STAFF REPORT

Community Planning and Preservation Commission Certificate of Appropriateness Request

Case No.:	21-90200066
Address:	2135 3 rd Avenue North
Legal Description:	BRONX BLK 9, LOT 13
Parcel ID No.:	24-31-16-11808-009-0130
Date of Construction:	1923
Local Landmark:	Kenwood Section – Southeast Kenwood Local Historic District (18-90300001)– Contributing Property
Owners:	Todd J. Bowman and Melissa A. Zepeda

Request: Review of a Certificate of Appropriateness for the demolition and reconstruction of a front porch at 2135 3rd Ave. N., a contributing resource to a local historic district

Figure 1: Proposed front façade elevation.

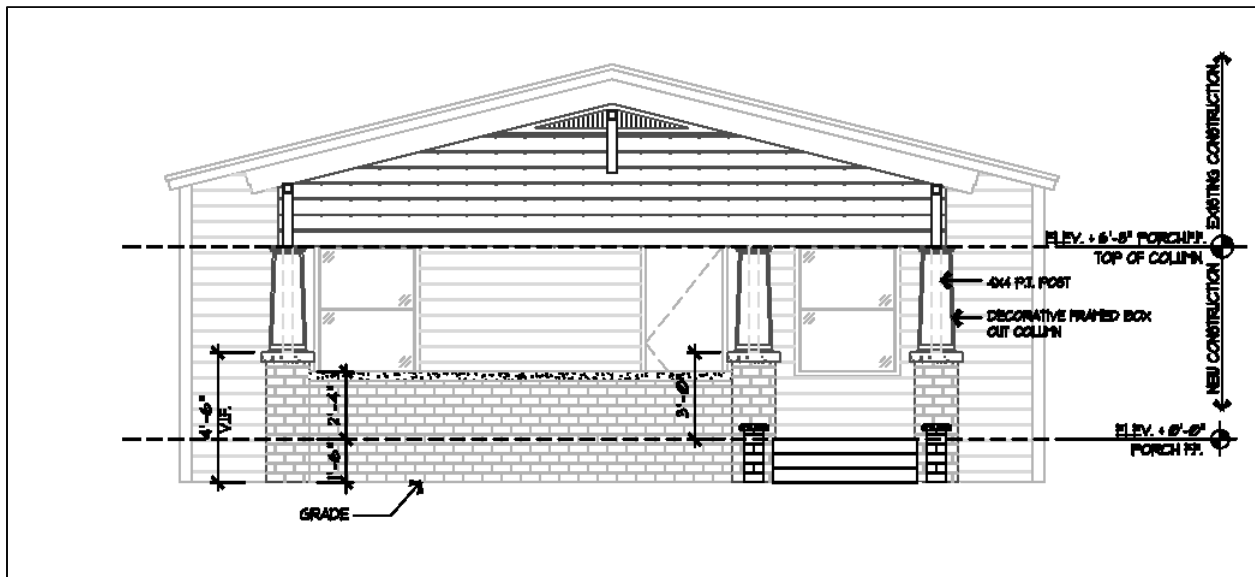
Consistent The proposed project will remove a historic portion of the contributing resource, but it appears this is necessary due to damage caused by a large tree. The proposed porch won't be an exact replica of the extant historic porch, but the proposed porch will contain traditional characteristics to the local historic district.

Consistent The proposed porch reconstruction is slightly different than the existing porch. Currently, the columns are brick that have been stuccoed over. Staff does not know if the stucco is original. The proposed porch will retain the same design, but will use CMU with brick veneer instead. Both brick veneer and stucco are traditional materials used for porches in this district.

The proposed porch will generally match the visual qualities of the extant porch. The extant porch is made of brick, but has been stuccoed over. It is unclear if the current stucco application is original or not. The proposed porch will have a brick veneer instead of stucco. The district is comprised of front porches with applied stucco and brick veneer, so the proposed design is compatible with the local historic district.

1. New siding will be wood lap siding with traditional dimensions and exposure.
2. A historic preservation final inspection will be required.
3. All other necessary permits shall be obtained. Any additional work shall be presented to staff for determination of the necessity of additional COA approval.
4. This approval will be valid for 24 months from the date of this hearing, with an expiration date of July 13, 2023.

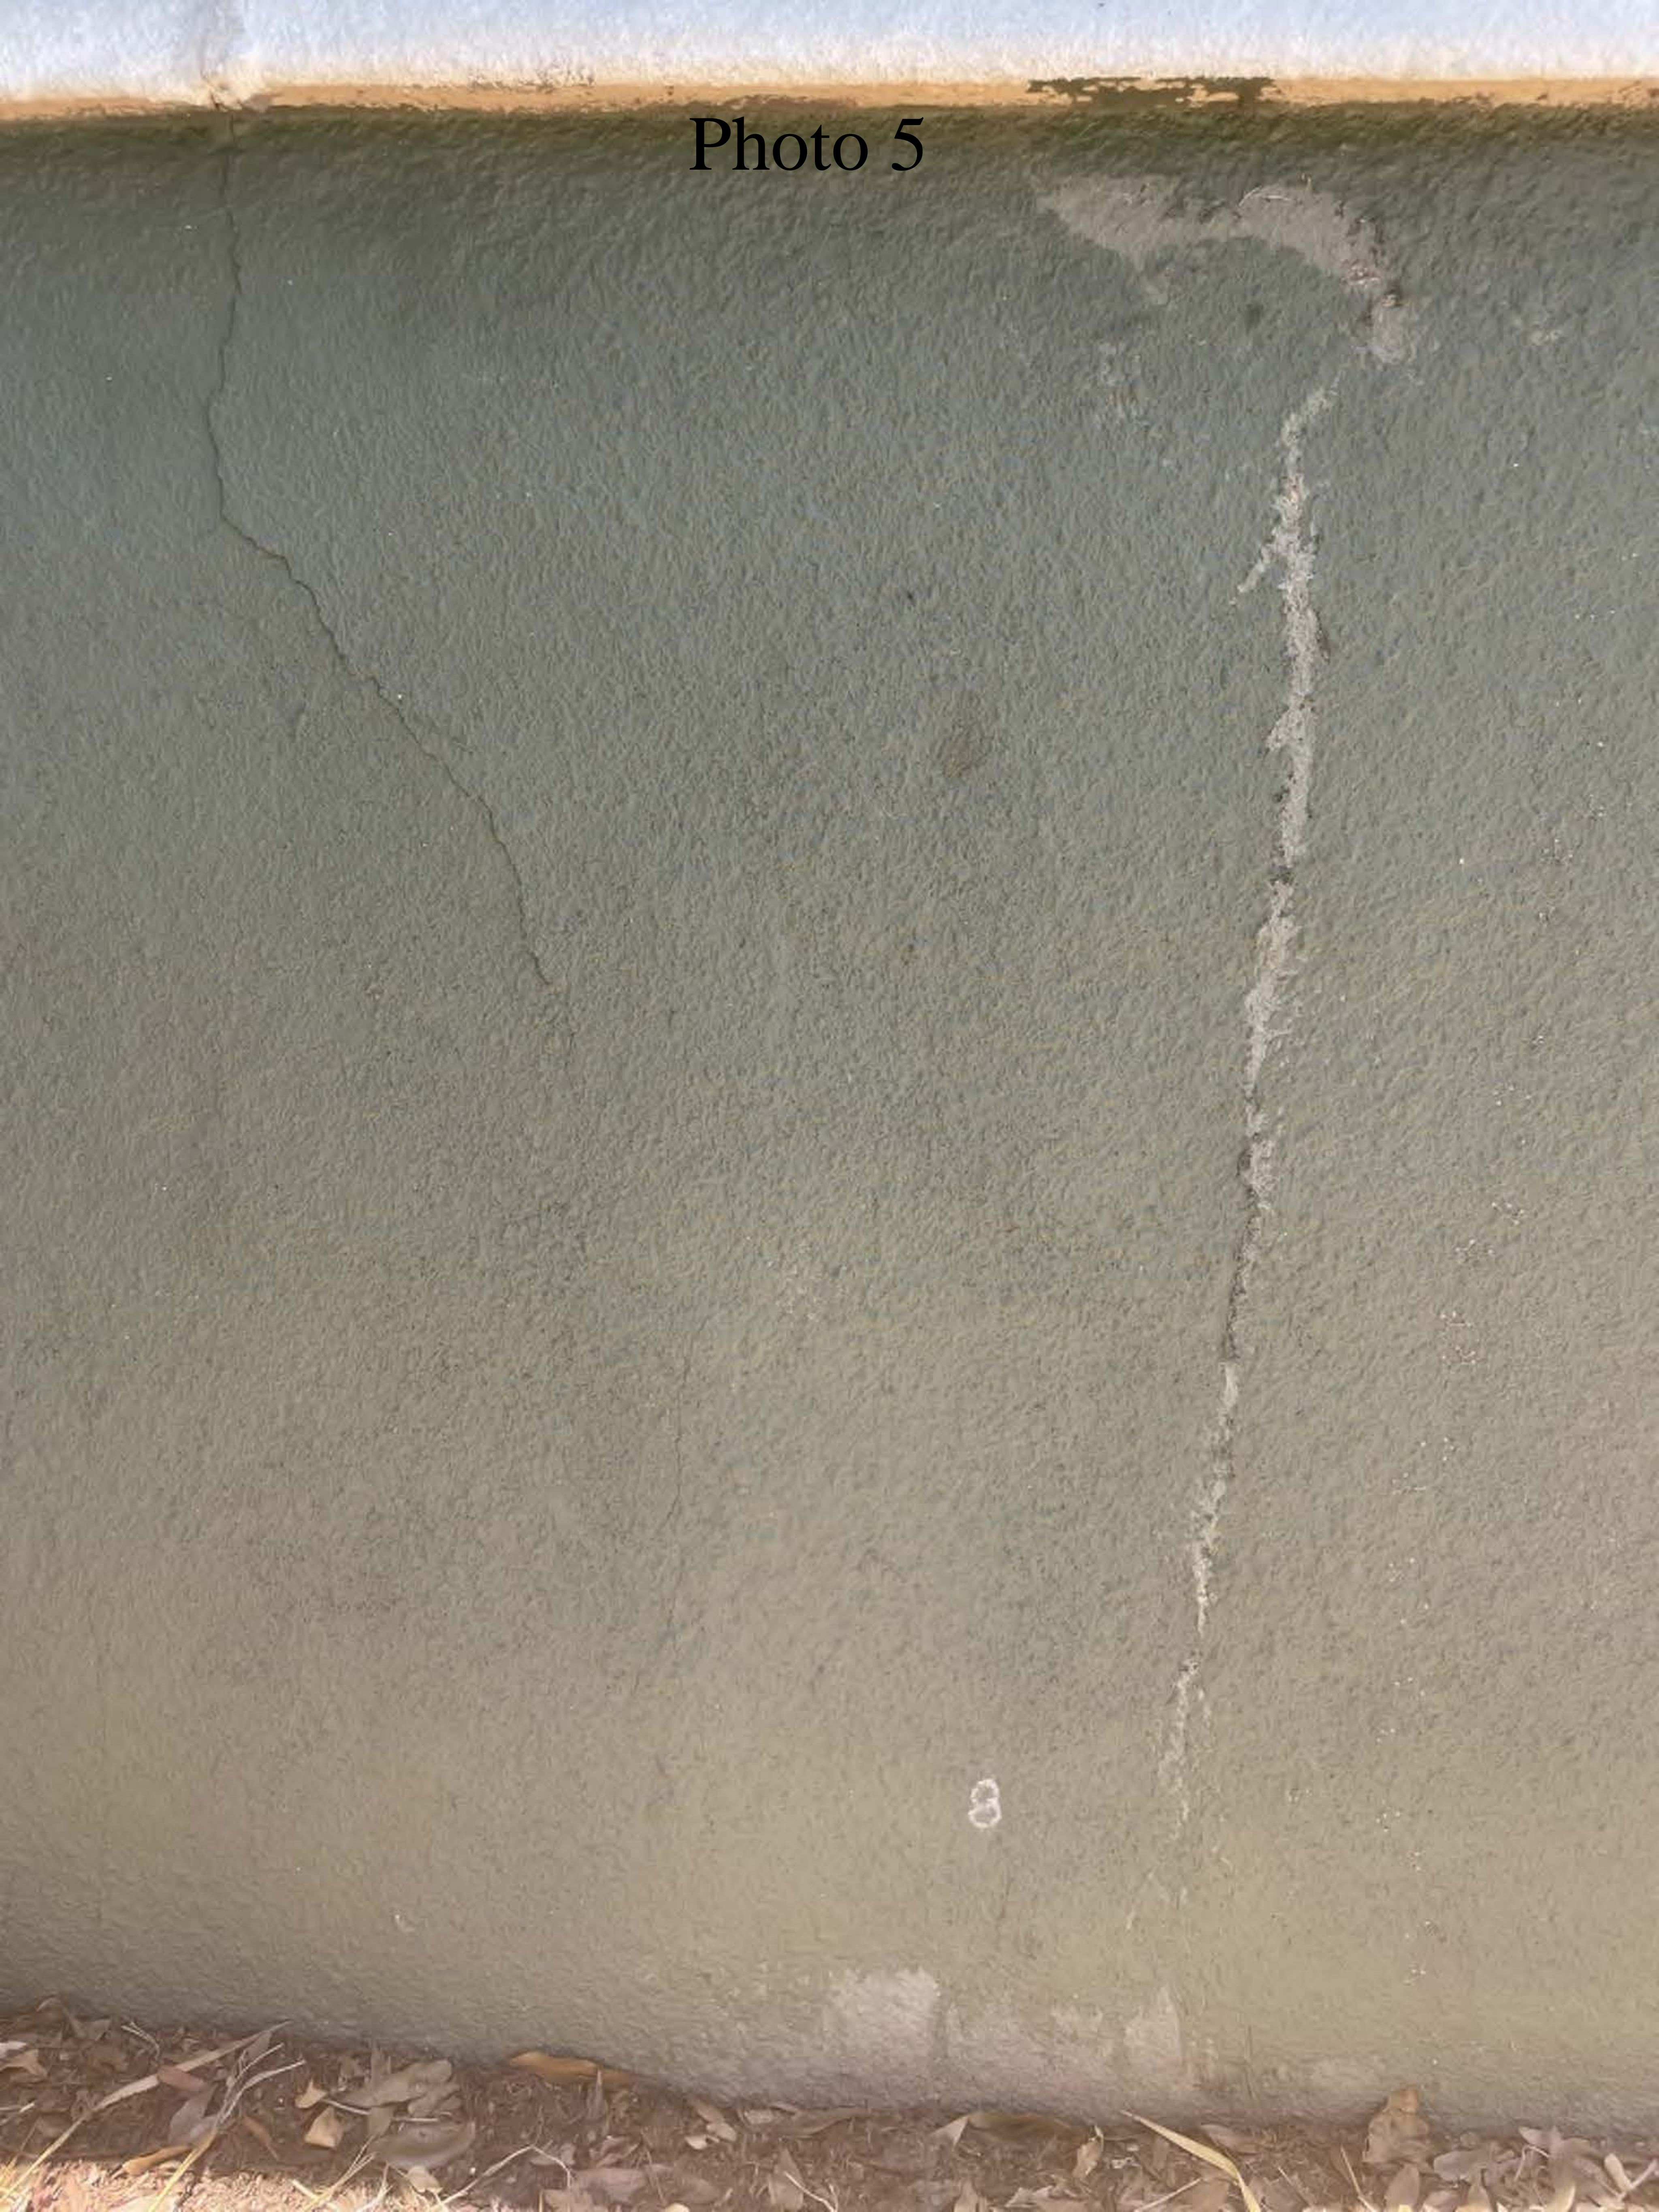
Figure 3: 2019 Google Streetview showing the large oak's impact on the front porch. Cracking is apparent in central column. Right column and front steps have shifted.

Consistent The application shows photographic evidence that the porch has been damaged from an adjacent tree and its roots. This was independently verified by historic preservation staff during a recent site visit. The deterioration, such as the wall separation and significant cracking and leaning of the columns, shows the need for repair and replacement.
